# Central Goldfields Shire Council

Planning Panels Victoria  
CGSC C031cgoI PART A  
Submission

**Date:** November 16 2020

**Figure 5: Exhibited Mapping in C031cgo1, 40 Pierce Hill Road, Dunolly (site indicated)**

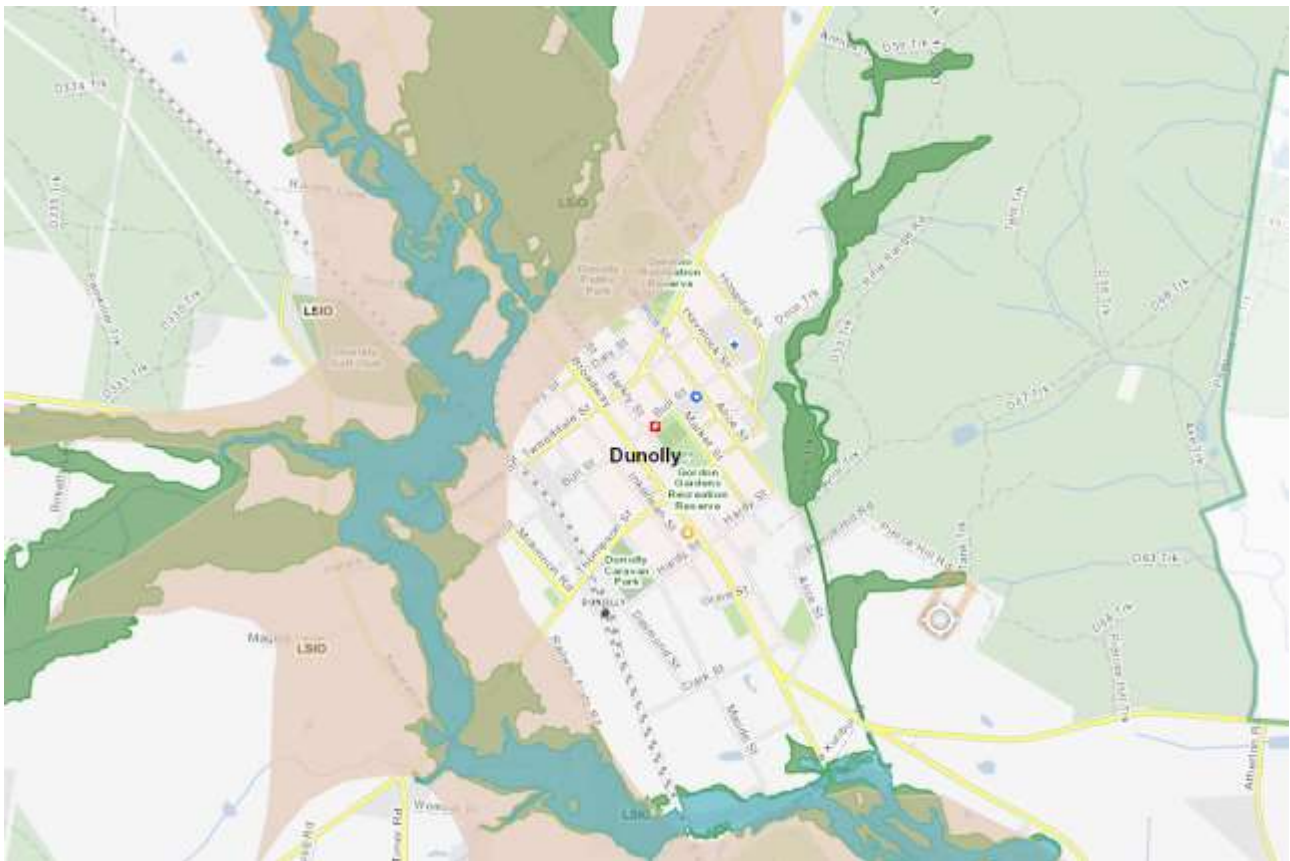
The submission does not support the proposed LSIO over a section of the property at 40 Pierce Hill Rd, Dunolly. The submitter agrees that although the direction of the water flow is correct, the extent of the inundation is inaccurate. The landowner contend that the water in the gully is at most 1m wide and approximately 30-40cm deep.

Council and NCCMA support mapping changes to Amendment C031cgo1 as shown above in Figure 5.

The submission was withdrawn in the 29 July 2020 as the submitter believes their request was resolved with the mapping update.
